RE: **Lot 16 Block 1 Unser Cliffs SAD 227**
6801 Rimrock NW
Grading and Drainage Plan
Engineers Stamp Date 12/16/18 (D10D014)
Pad Certification Date 1/24/19

Based upon the information provided in your submittal received 1/25/19, this plan is approved for Building Permit.

DRAINAGE AND TRANSPORTATION INFORMATION SHEET (REV 6/2018)

ENGINEER'S SEAL 12/16/18 DAVID SOULE P.E. #14522	6809 RIM ROCK	DRAWN BY: WCUJ
	GRADING AND DRAINAGE PLAN	DATE: 12-16-18
	 1606 CENTRAL AVENUE SE SUITE 201 ALBUQUERQUE, NM 87106 (505) 872-0999	218157-LAYOUT-12-16-18
		SHEET #
		JOB # 218157

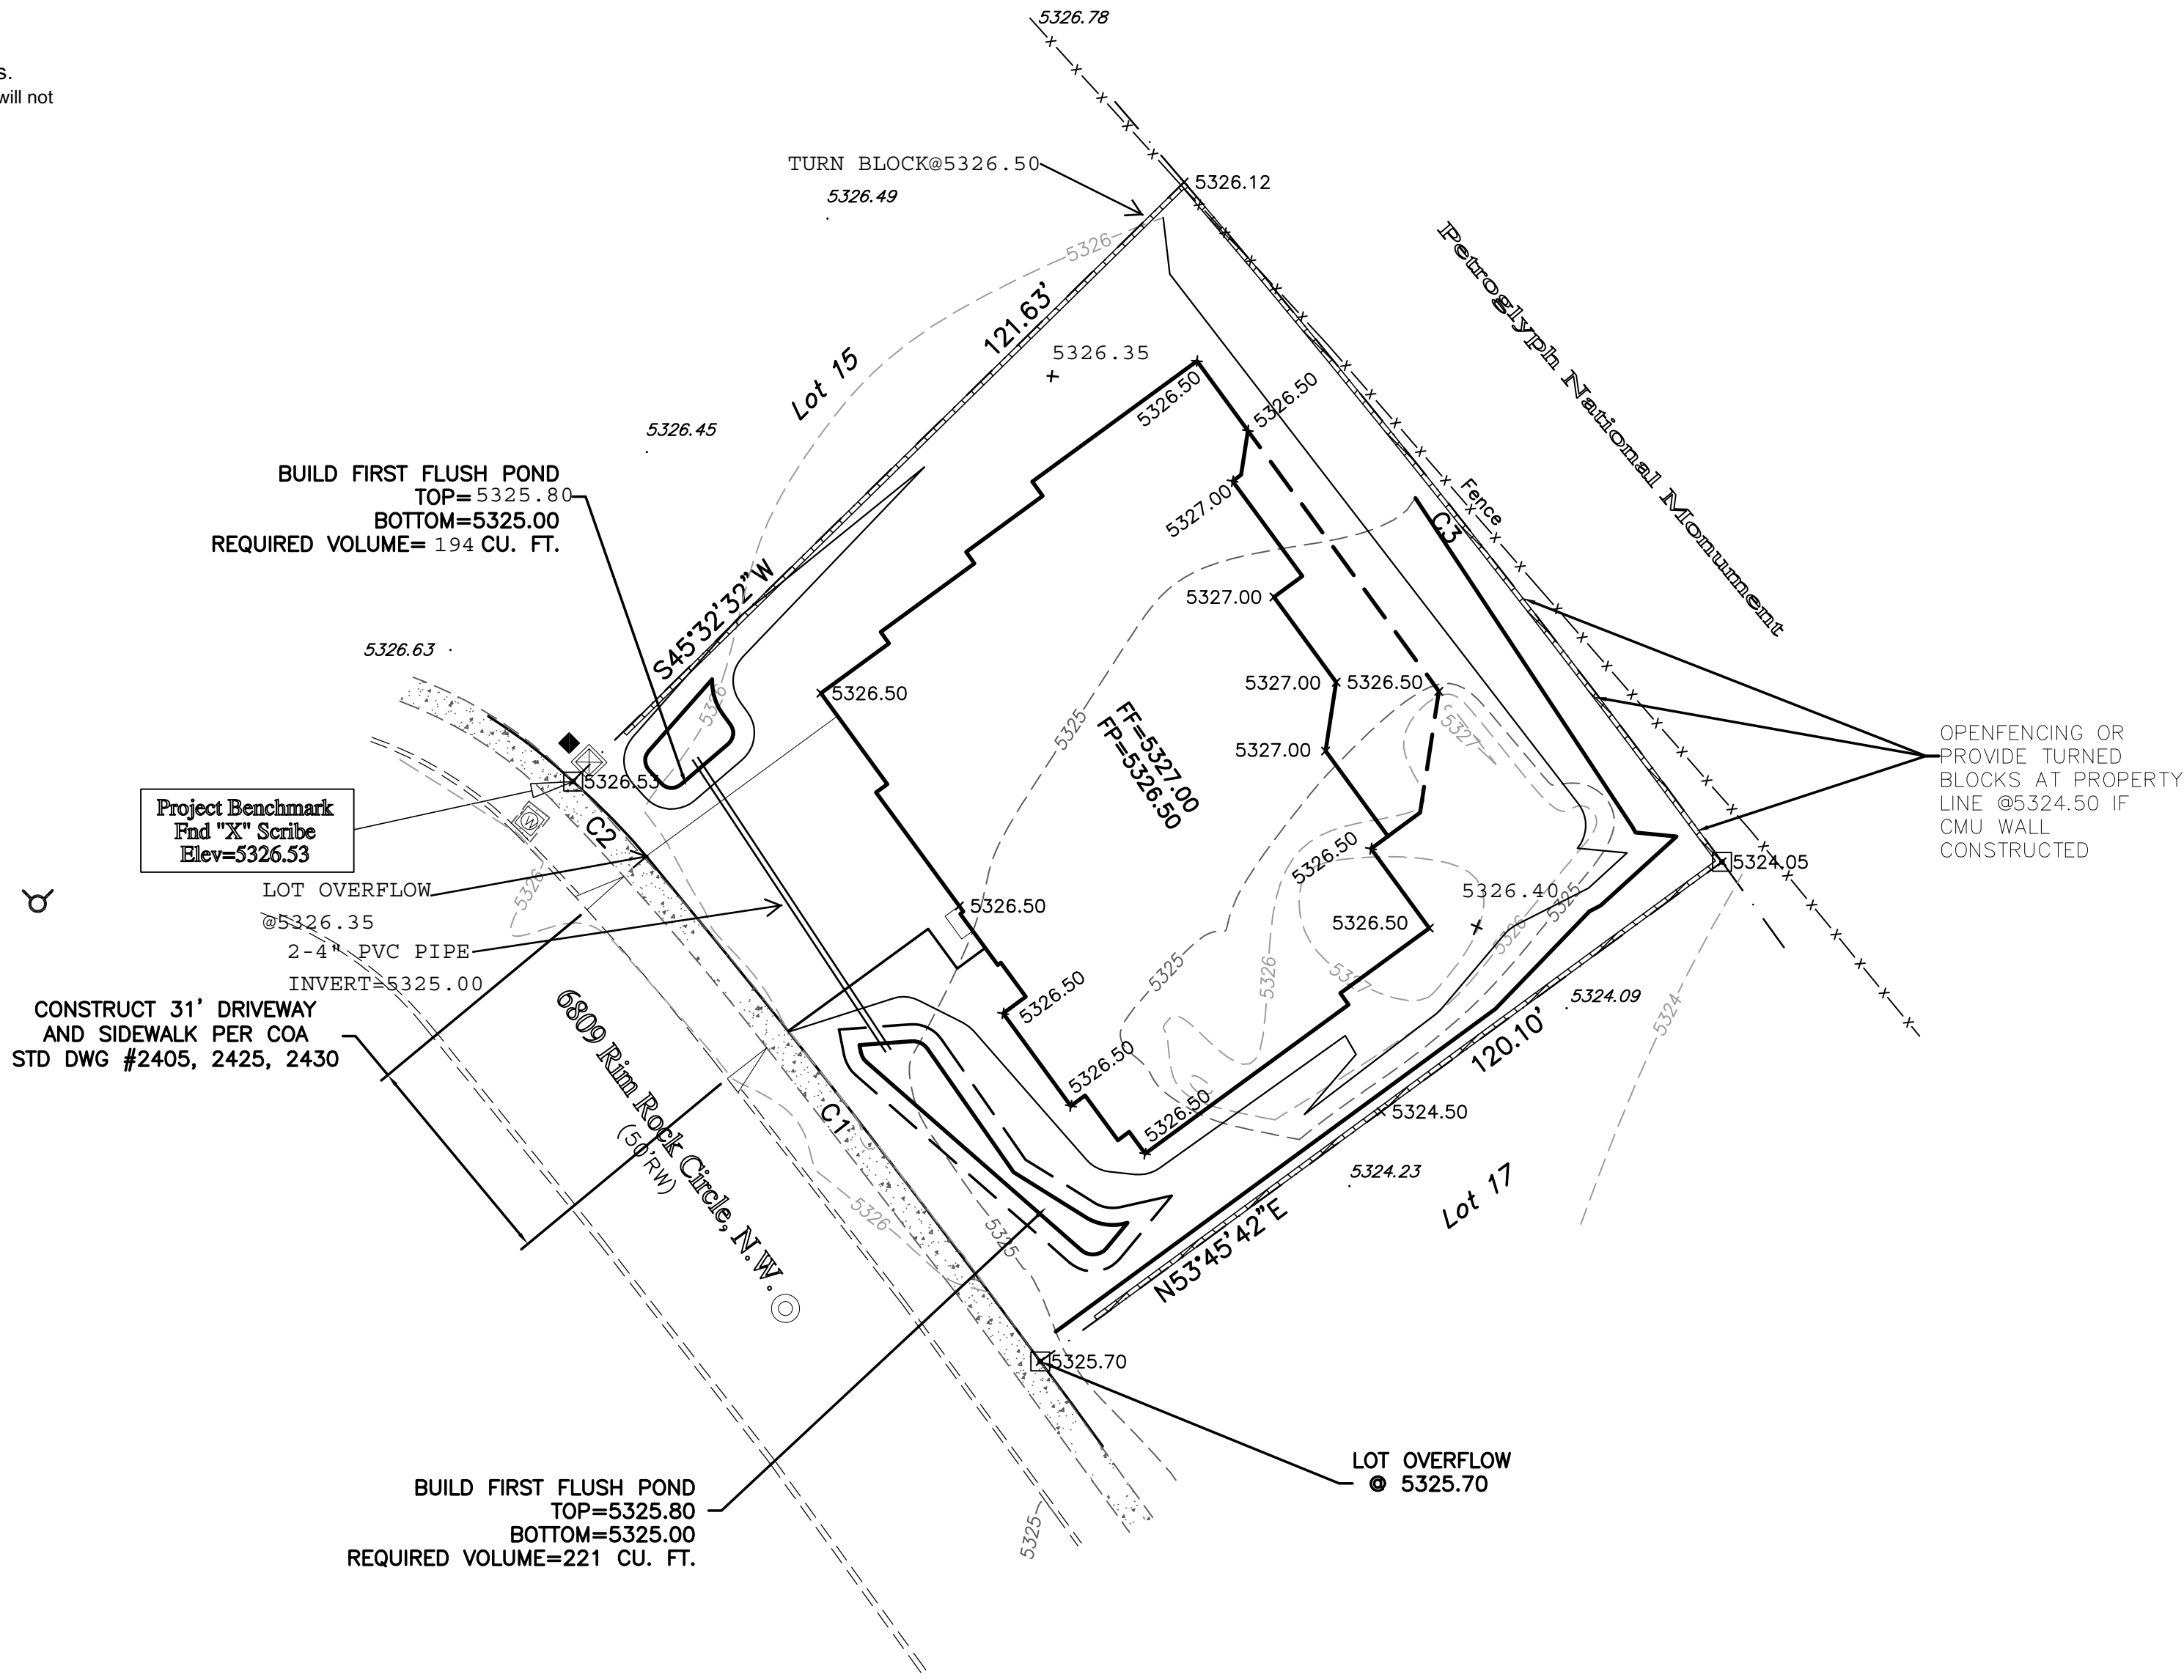
Reiterate to the Owner/Contractor that a separate permit for a garden/retaining wall must be obtained, with the approved G&D plan dated 12/16/18.

Prior to Certificate of Occupancy release, Engineer Certification per the DPM checklist of this plan will be required.
